H. B. ROBINSON STEAM ELECTRIC PLANT, UNIT NO. 2
DOCKET NO. 50-261/LICENSE NO. DPR-23

RESPONSE TO PRELIMINARY ACCIDENT PRECURSOR ANALYSIS FOR MARCH 28, 2010 OPERATIONAL EVENT

Input to Preliminary Accident Sequence Precursor Analysis of March 28, 2010 Event

Figure 1

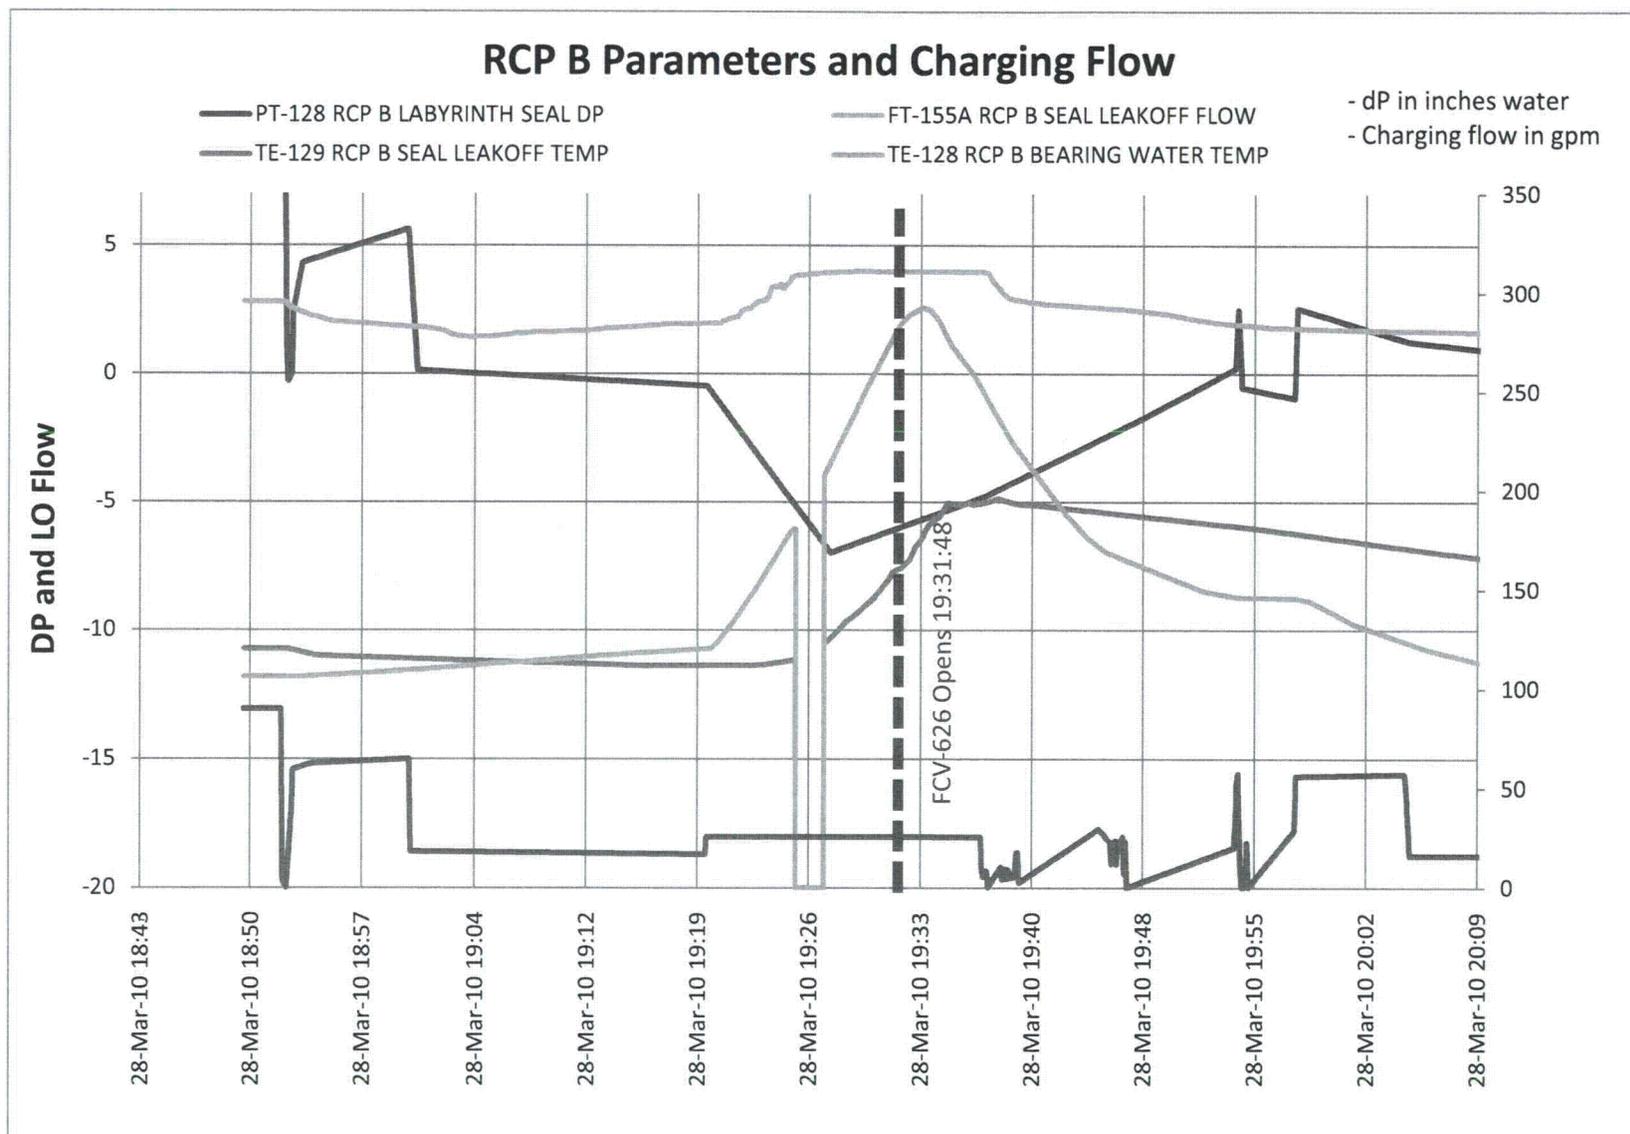
Figure 1 shows that at approximately 19:19, the B RCP bearing water temperature rise rate increased significantly. Labyrinth seal differential pressure shows a corresponding rate change at this point. These changes indicate that the portion of the PBV below the bearing was being purged by hot RCS water coming from the RCP casing. Therefore, it may be concluded that at this point seal water injection cooling was no longer effective. Since FCV-626 was still closed at this time, it may be concluded that neither seal water injection nor thermal barrier cooling was effective from approximately 19:19 to 19:32 when FCV-626 was reopened (approximately 13 minutes duration).

The data shows that about 40 minutes after the B RCP reached stand still, the seal leakoff temperature exceeded the continuous operation limit of 190°F, and remained above 190°F for a brief period of time (approximately 9 minutes). The data also shows that the maximum seal leakoff temperature (approximately 196°F) did not encroach upon the special operation limit (referred to as the “shutdown temperature” in TB-04-22 Rev 1) of 235°F. The Vendor technical manual (VTMA 728-621-13) and TB-04-22 Rev 1 state that seal thermal shock can be avoided if cooling is restored before the seal leakoff temperature exceeds 235°F.

The ineffective seal cooling event essentially ended when FCV-626 was opened at 19:32. As can be seen in Figure 1, the seal leakoff and bearing water temperatures peaked, and began to decrease shortly after this point. If FCV-626 had not been reopened at that time, the seal leakoff temperature would have continued to increase. Review of PI data reveals that the rate of rise for the B RCP seal leakoff temperature, just before the temperature was influenced by restoration of thermal barrier cooling and flattened out around 19:35:20, was 12.66°F/min. This temperature rise rate is higher than either the seal leakoff temperature rise rate of 8.17°F/min that was experienced before FCV-626 was opened at 19:32, or the temperature rise rate of 10.22°F/min from when FCV-626 was opened until the seal leakoff temperature stopped increasing at 19:35:20. Using the RCP B seal leakoff temperature at 19:35:20 of 193.79°F, and a temperature rise of 12.66°F/min, the shutdown temperature of 235°F would be encroached upon at 19:38:30. Therefore, based on this temperature rise rate, the FCV-626 opening time margin was 6.5 minutes (i.e., opening of FCV-626 could have been delayed by up to 6.5 minutes without the RCP B seal leakoff temperature exceeding the shutdown temperature).

The analysis shows that opening of FCV-626 to reestablish thermal barrier cooling for RCP B could have been delayed for at least 5.9 minutes before the seal leakoff temperature would be expected to exceed the special operations limit (i.e., shutdown temperature) of 235°F. However, based on Westinghouse analysis, testing and field experience regarding restoration of seal cooling above 235°F, a significant increase in seal leakage would not have occurred even if cooling was restored above this limit. Therefore, opening of FCV-626 to reestablish thermal barrier cooling for RCP B could have been delayed for significantly more than 5.9 minutes with no substantive increase in seal leakage expected. These conclusions also apply to RCPs A and C since it has been shown that the seal cooling transient experienced by these RCPs was less severe than that experienced by RCP B.

Figure 1 – RWST Depletion Timing Following 2 RCP Seal LOCAs

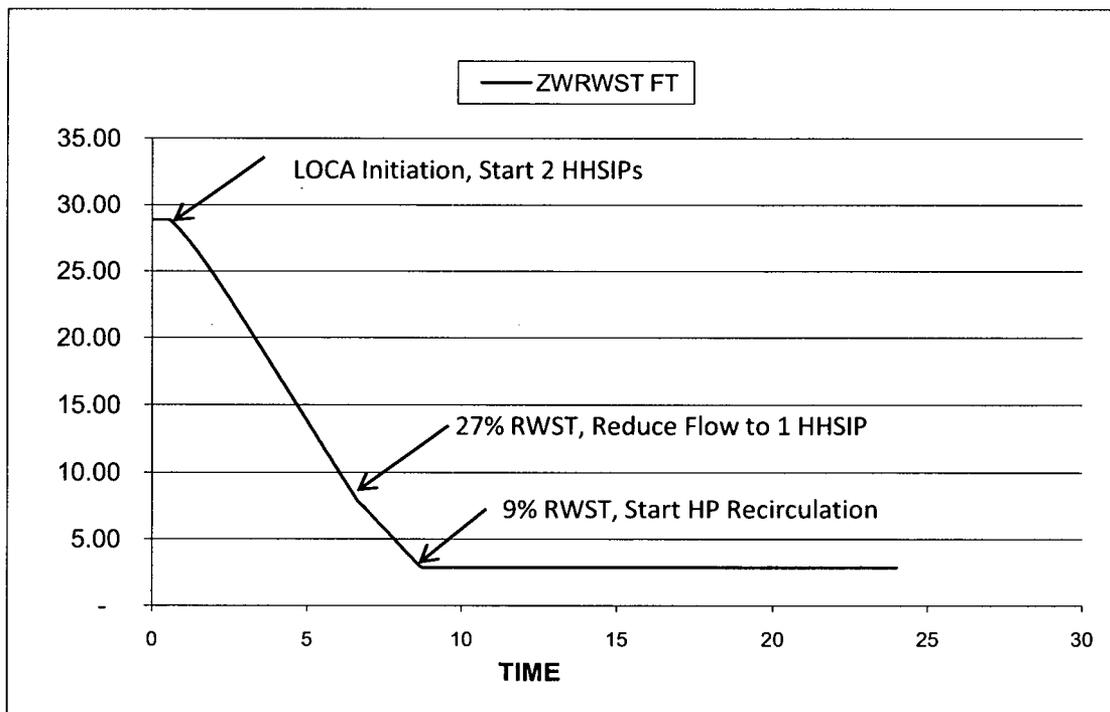
MAAP 4.05 was used to determine the event timing of a loss of RCP seal cooling and a subsequent catastrophic seal failure for 2 and 3 RCPs respectively. Three MAAP cases are provided that show variations in number of RCP seal failures and the number of HHSI pumps credited. The variables of interest for these runs is the timing to RWST level at 27%, to entry point for EPP-9, Transfer To Cold Leg Recirculation, and the timing available to establish recirculation flow. A summary of the inputs and results are shown for each case below and a detailed discussion of the MAAP analysis follows.

The MAAP analysis was programmed to address the best estimate prediction of the events on March 28th, 2010 if catastrophic RCP seal failure had occurred. During the event, the plant overcooled and an SI was initiated. To mimic this effect in MAAP, the secondary plant is isolated and a cooldown is initiated at time zero. AFW successfully starts following the loss of the secondary plant. Multiple 480 gpm RCP seal LOCAs occur at 30 minutes due to running RCPs after a loss of seal cooling. The cooldown is continued post LOCA as would be directed in EPP-8. During the event, the plant responds as expected. The core remains covered throughout each simulation. The containment pressure does not exceed 10 psig and containment spray is not actuated during the simulations.

Figure 2 – RWST Depletion Timing Following 3 RCP Seal LOCAs

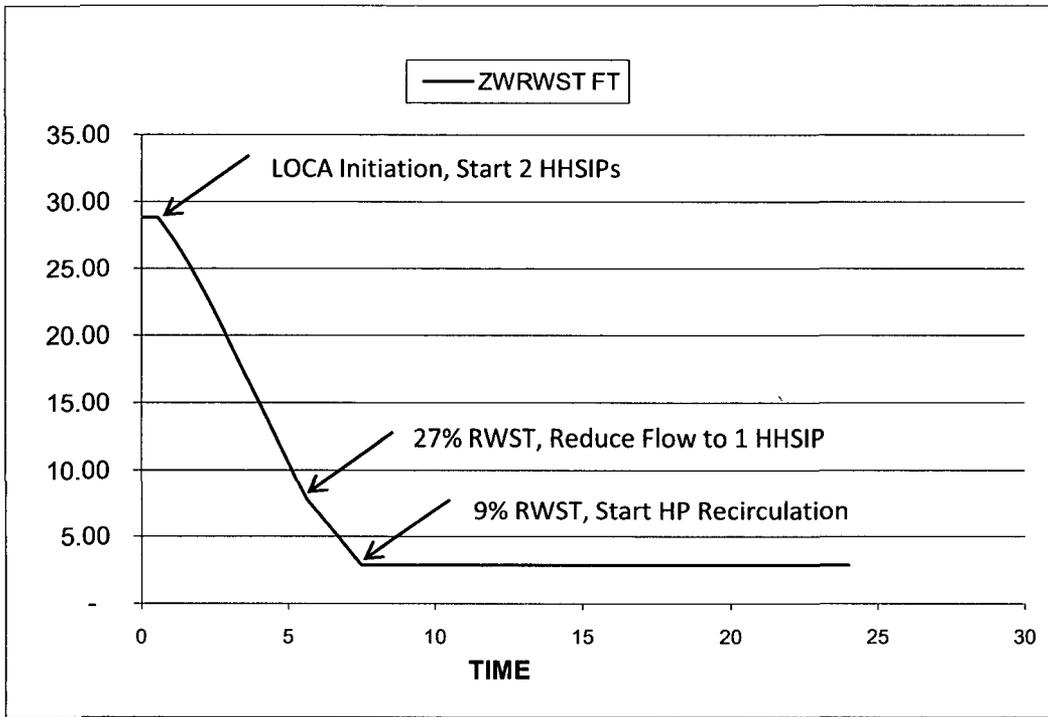
matches the break flow capacity. However, the combined flow rate if two pumps is higher than if only one SI pump were running. Case 2 shows that the resultant higher pressure causes more inventory loss out the break and a faster RWST depletion. Case 3 shows that with one HHSI pump running, the RCS pressure stabilizes at a lower pressure, but flow from the single HHSI pump (and the break flow) is less than that of two pumps, resulting in a slower RWST depletion. The third variable affecting RWST depletion is the break size. If the RCP seal LOCA only occurs on 2 RCPs (Case 1) versus 3 RCPs (Case 2), the time to RWST depletion is increased by over one hour.

Figure 2 – Case 3: RWST Depletion Timing Following 3 RCP Seal LOCAs with 1 HHSI pump Injecting.

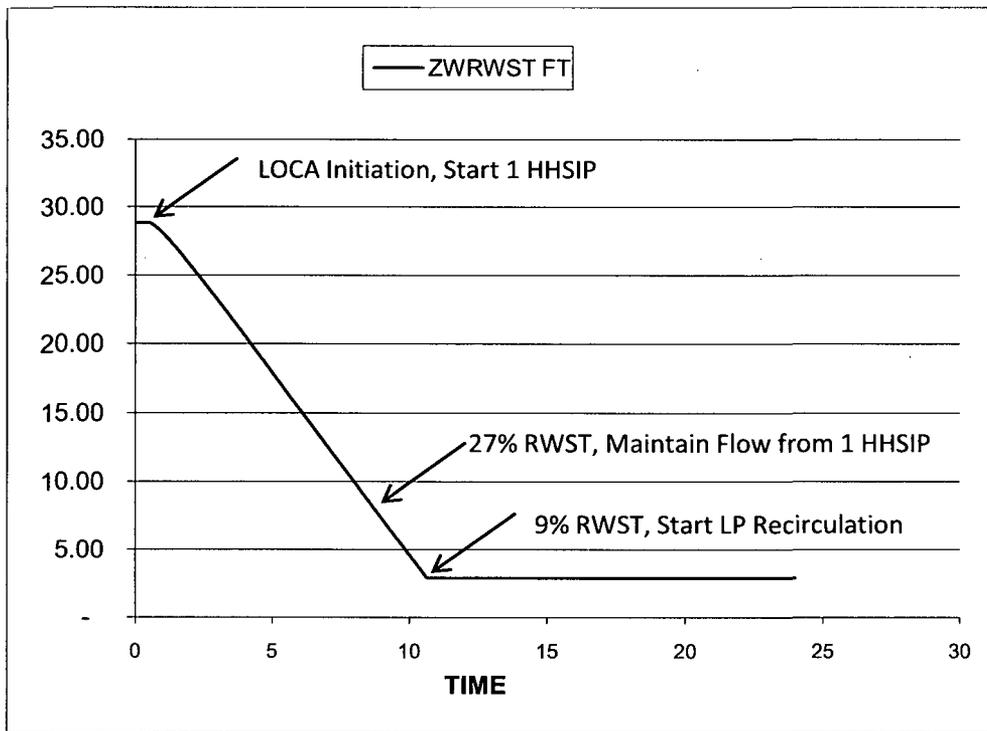
Case 3 indicates that low pressure recirculation is a success path versus high pressure recirculation. Sensitivity analyses indicate that either option, low pressure recirculation or high pressure recirculation, is successful for all three cases. During injection, the break size is small enough that RCS pressure remains higher than the RHR pump shutoff head. Based on the specific order of steps in the procedure, HP recirculation will be chosen over LP recirculation based on the higher RCS pressure during injection.
